Economic Commission for Europe

Vehicle with sliding sheets

Submitted by the International Association of the Body and Trailer Building Industry

3. In Annex 2, Article 4, Vehicle with sliding sheets, amend to read:

Sketch No. 10

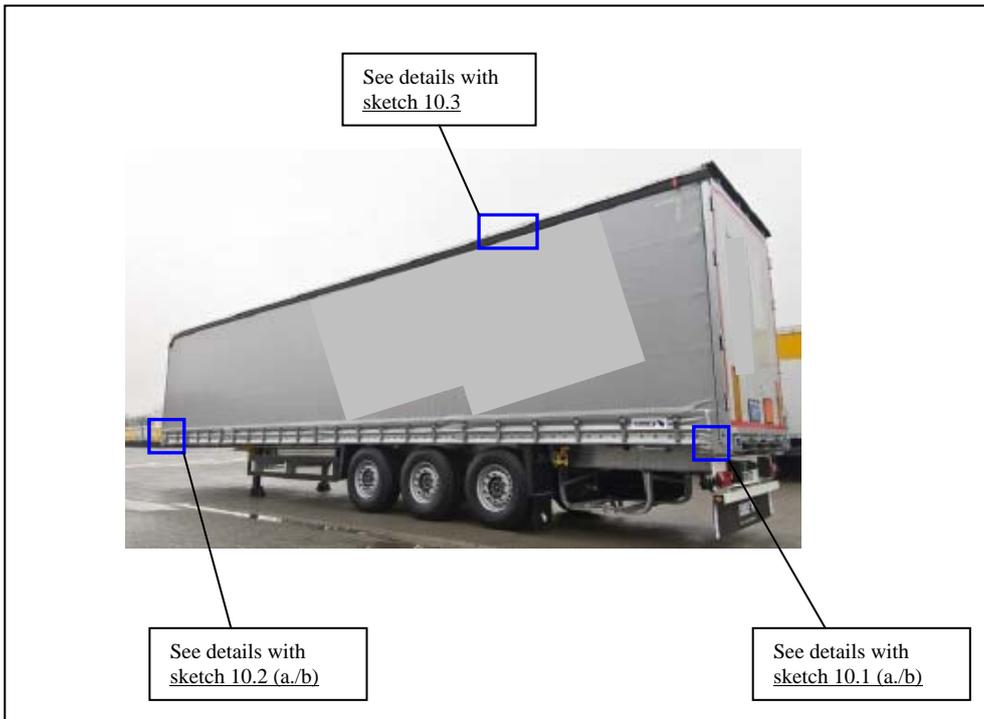
“2. The sliding sheets (**e.g. sliding side walls and roof**), floor, doors and all other constituent parts of the load compartment shall fulfil either the requirements in Article 3, paragraphs 6,8,9 and 11 of these Regulations or the requirements set out in (i) to (vi) below

(i) The sliding sheets **and roof**, floor, doors and all other constituent parts of the load compartment shall be assembled in such a way that they cannot be opened or closed without leaving obvious traces”.

Vehicle Example: This sketch shows a further example of a vehicle and of important points described with additional sketches and information.

Sketch No. 10.1

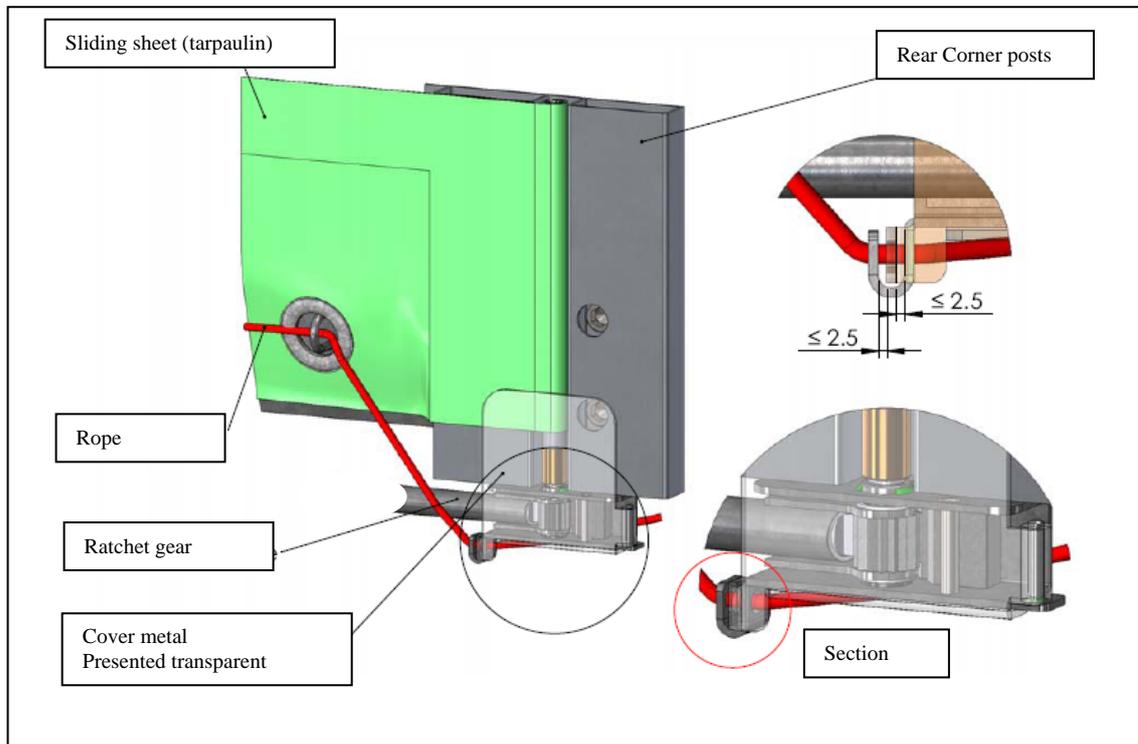
To tighten the tarpaulin in horizontal direction, a ratchet gear is used (normally on the rear end of the vehicle). This sketch shows two examples (a. and b.) how the ratchet or gearbox can be secured.

(a) Ratchet securing

(a) Cover metal

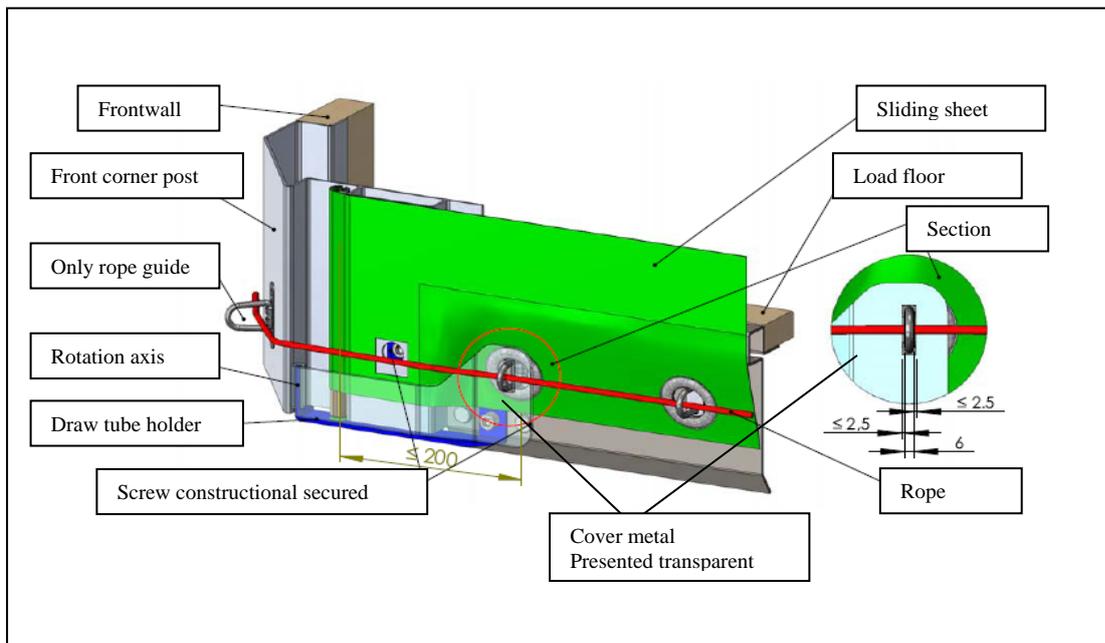
To fix the tarpaulin on the other side (normally to the front of the vehicles) the following systems (a. /b.) can be used.

**Sketch 10.3**

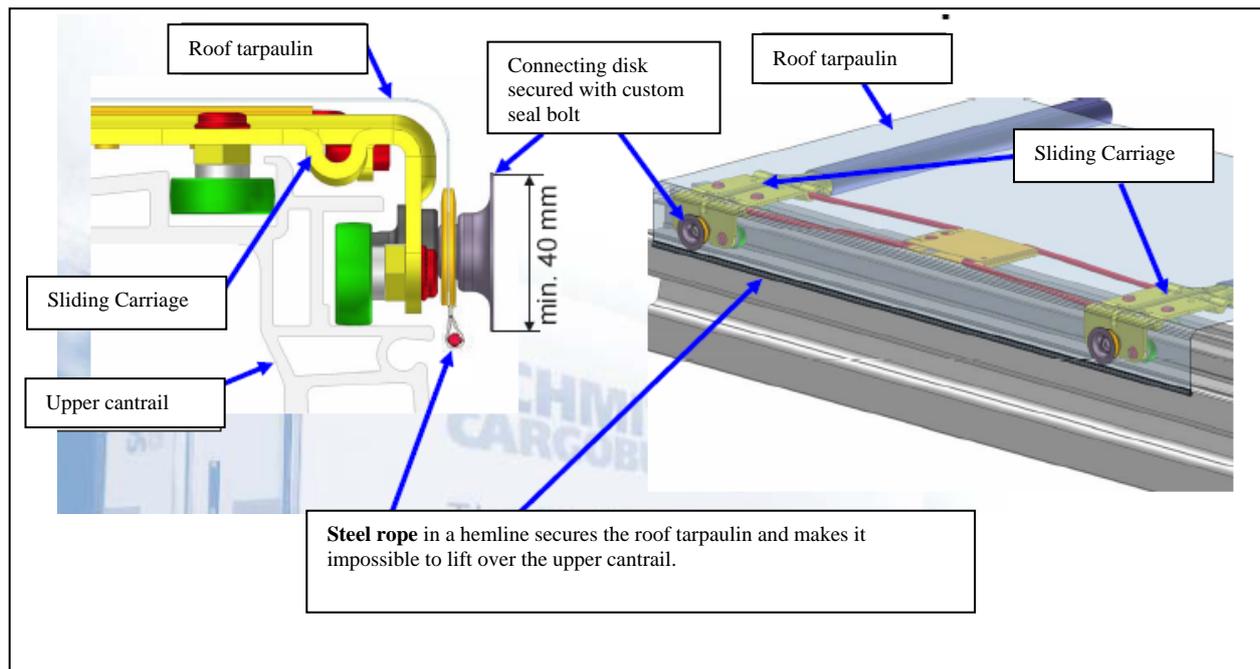
The custom security of the sliding roof is guaranteed if a prestressed steel rope, embedded in a hemline, is fixed. This steel rope is fixed to the front and rear of the vehicle. The tractive force as well as the connecting disk on each sliding carriage, makes it impossible to lift up the hemline with the steel rope above the upper cantrail.
